Subject: Oyster Creek Nuclear Generating Station
Docket No. 50-219
SEP Topic III-5.B, Pipe Break
Outside Containment

JCP&L RESPONSES TO
NRC STAFF POSITIONS ON SEP TOPIC III-5.B
PIPE BREAKS OUTSIDE CONTAINMENT
OYSTER CREEK NUCLEAR PLANT

JCP&L RESPONSES TO
NRC REQUEST FOR ADDITIONAL INFORMATION
SEP TOPIC III-5.B, PIPE BREAK OUTSIDE CONTAINMENT
OYSTER CREEK

CONTAINMENT PENETRATION MAIN STEAM

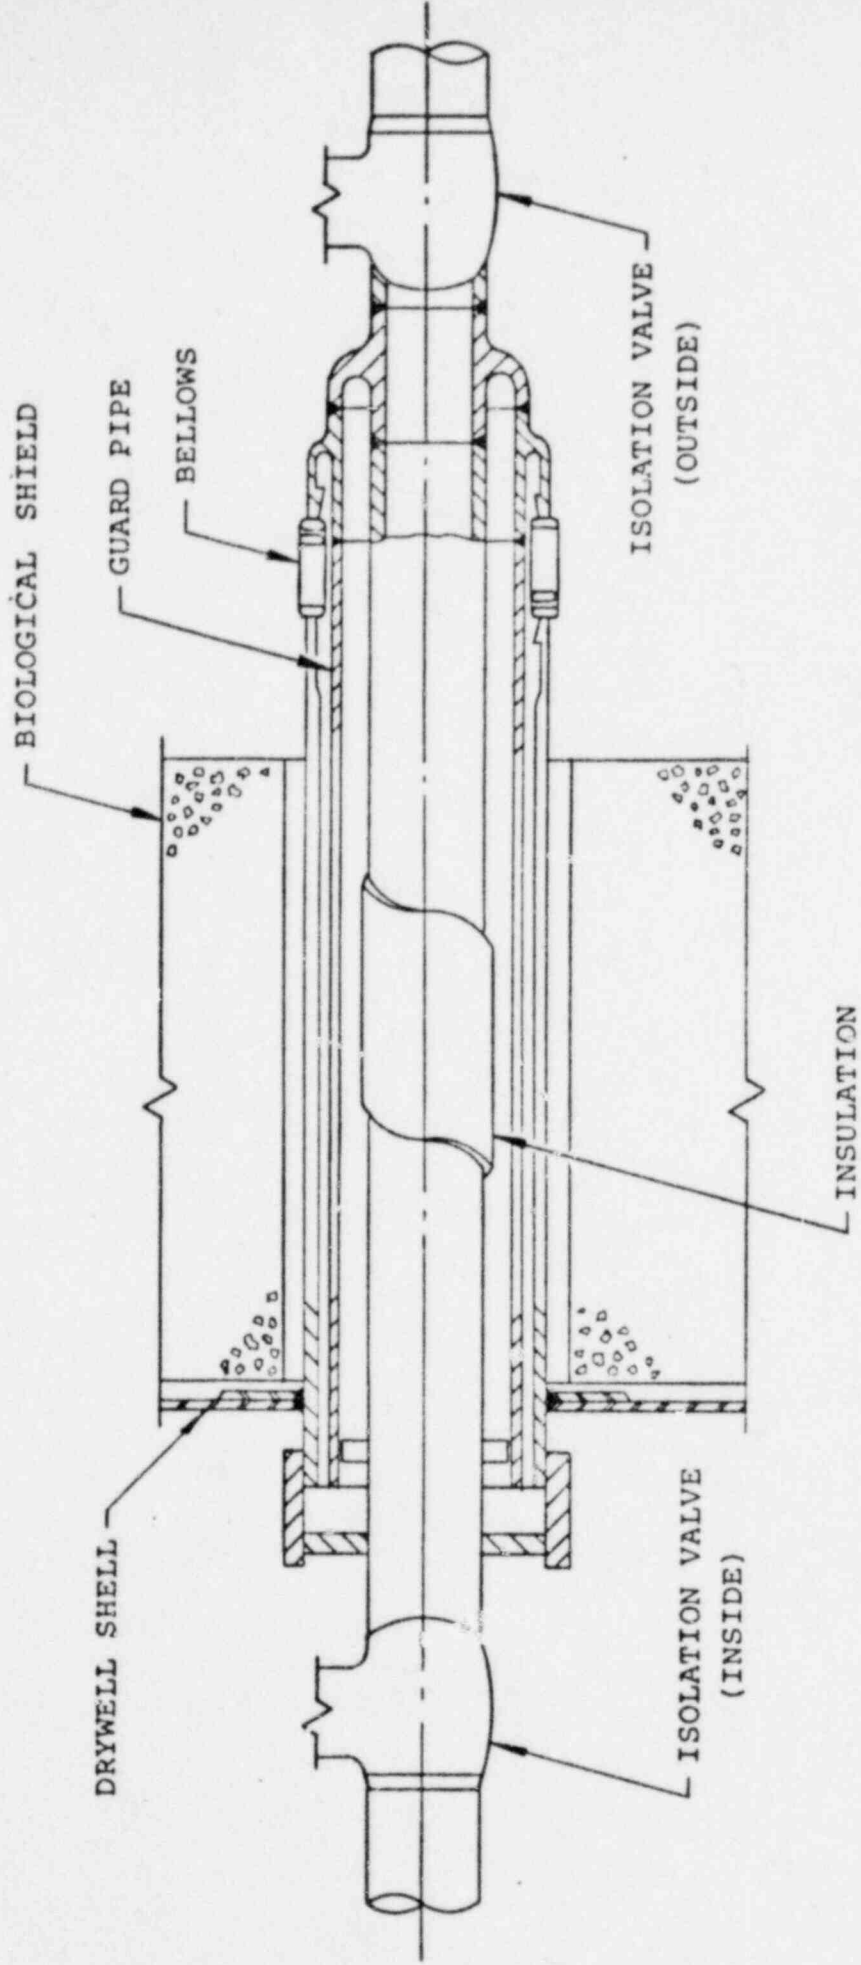
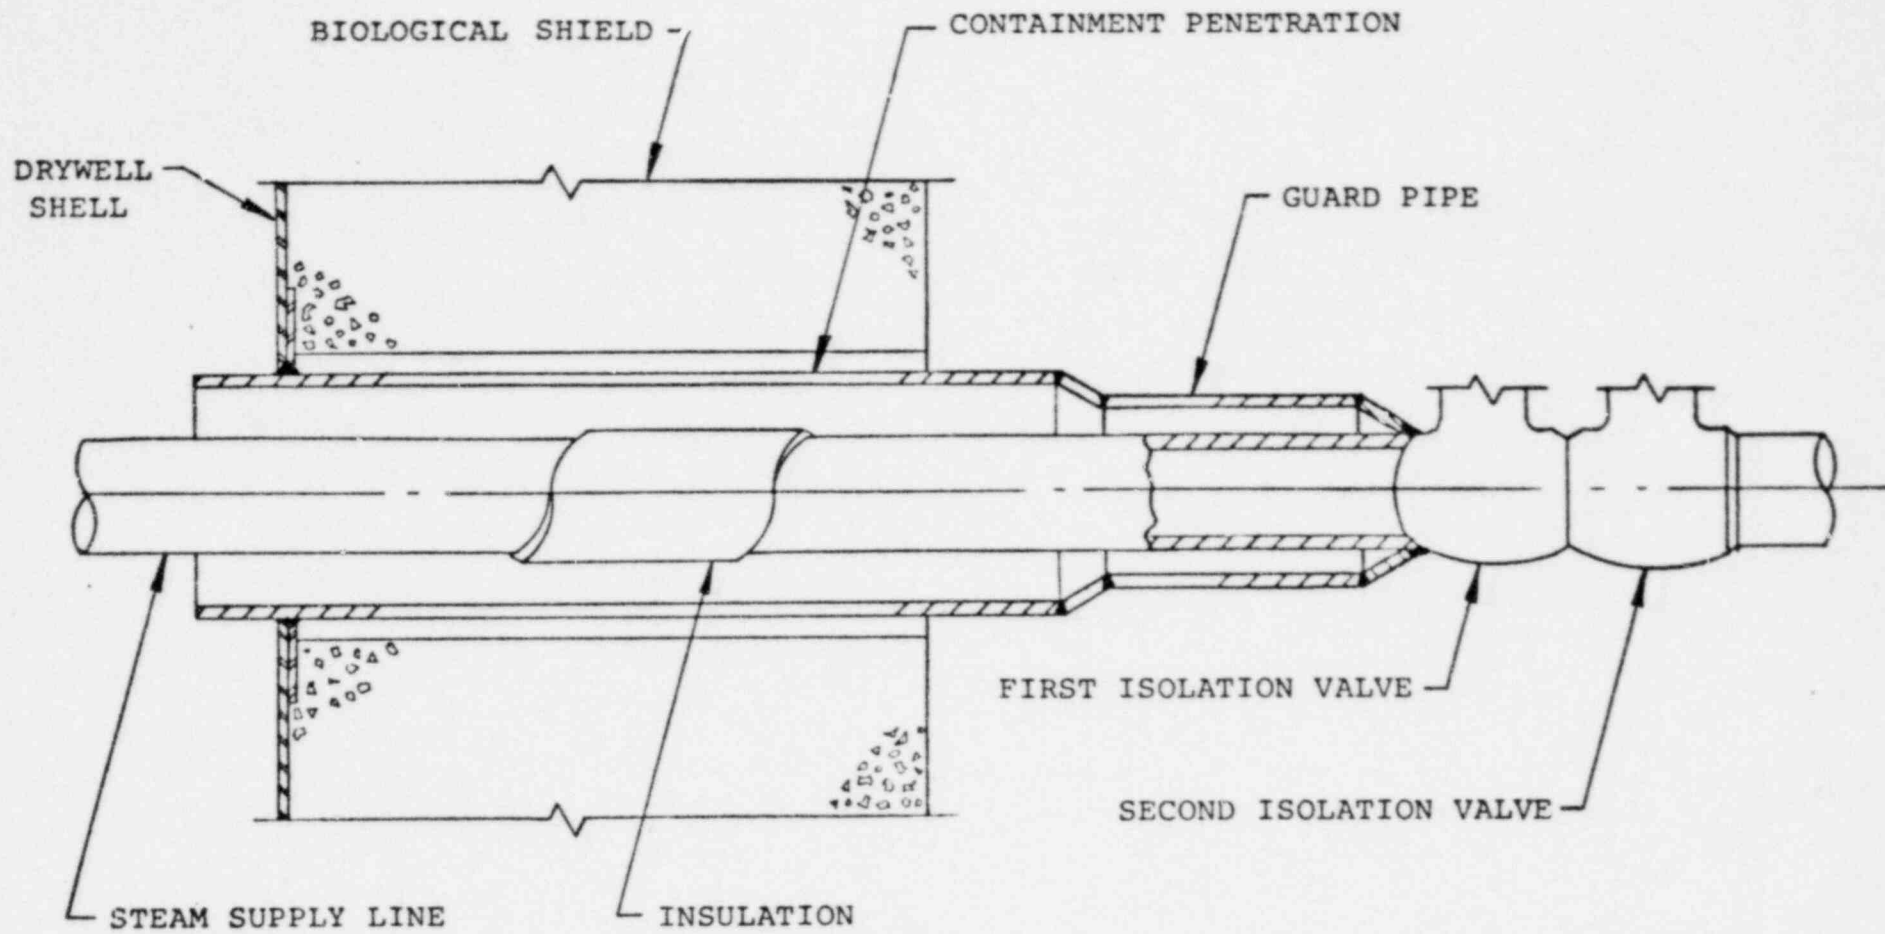
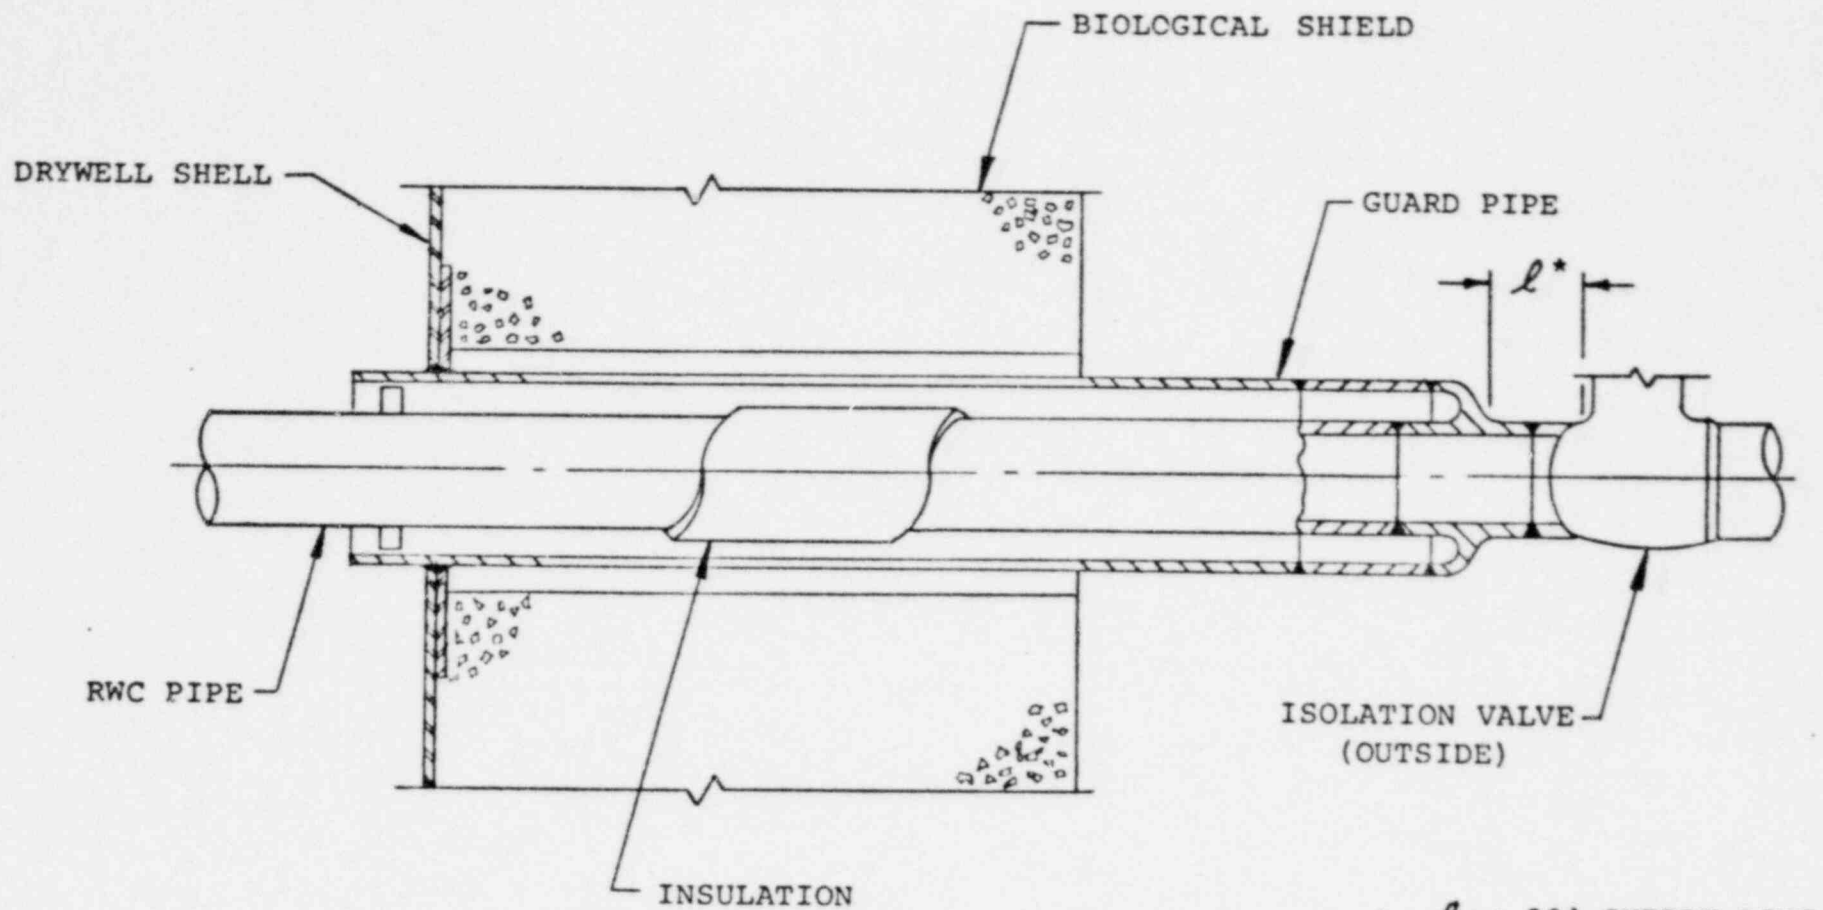
Provide a comparison of the design of the containment penetration piping outside containment between the containment and the outermost containment isolation valves for the main steam lines, emergency condenser steam and condensate lines, and reactor water cleanup lines with the provisions of Section B.1.b of Branch Technical Position MEB 3-1 (appended to Standard Review Plan 3.6.2) in sufficient detail to identify the degree of conformance with and the deviations from these provisions.

Branch Technical Position (BTP) MEB 3-1 states that pipe breaks need not be postulated in fluid system piping in containment penetration areas that meet the requirements of Section B.1.b. Typical containment penetrations for the main steam, emergency condenser, and reactor water cleanup lines are shown in figures 1, 2 and 3, respectively. A comparison of the design of the Oyster Creek containment penetrations and piping outside containment for the main steam, emergency condenser, and reactor water cleanup lines with the provisions of Section B.1.b of BTP MEB 3-1 is given in Table 1. In summary, it is concluded that the Oyster Creek containment penetrations and piping outside containment meet the intent of the provisions of Section B.1.b of BTP MEB 3-1 except as noted below.

- a. BTP MEB 3-1 requires that fluid system piping in containment penetration areas meet the requirements of NE-1120 of the ASME Code Section III. NE-1120 requires that pipes and valves which are part of the containment or are attached to the containment shall be classified as Class 1 or Class 2 and meet the requirements of the applicable subsection of the Code. The main steam, emergency condenser, and reactor water cleanup piping systems for Oyster Creek were designed and constructed in accordance with the Code for Pressure Piping ASA B31.1 (1955). However, the margin of safety provided by ASA B31.1 is considered to be comparable to that provided by ASME Code Section III. Therefore, the Oyster Creek piping is considered to meet the intent of BTP MEB 3-1 in this regard.

- b. The design stress limits for Oyster Creek piping for normal and upset plant conditions plus seismic loads were different from those specified in BTP MEB 3-1, as indicated in Table 1. However, the margin of safety provided by the Oyster Creek limits is considered comparable to that provided by the limits specified in BTP MEB 3-1.

- c. BTP MEB 3-1 requires that piping between the containment penetration and pipe whip restraint located outboard of the outside isolation valve be analyzed for postulated pipe breaks beyond the restraint and meet certain stress limits. As indicated in Table 1, there are no pipe whip restraints on the Oyster Creek main steam, emergency

condenser, and reactor water cleanup lines outboard of the outside isolation valves. Because of the lack of pipe whip restraints, the Oyster Creek piping systems between the containment penetration and isolation valve outside containment do not meet the stress requirements of BTP MEB 3-1 with regard to pipe breaks beyond the outside isolation valve.
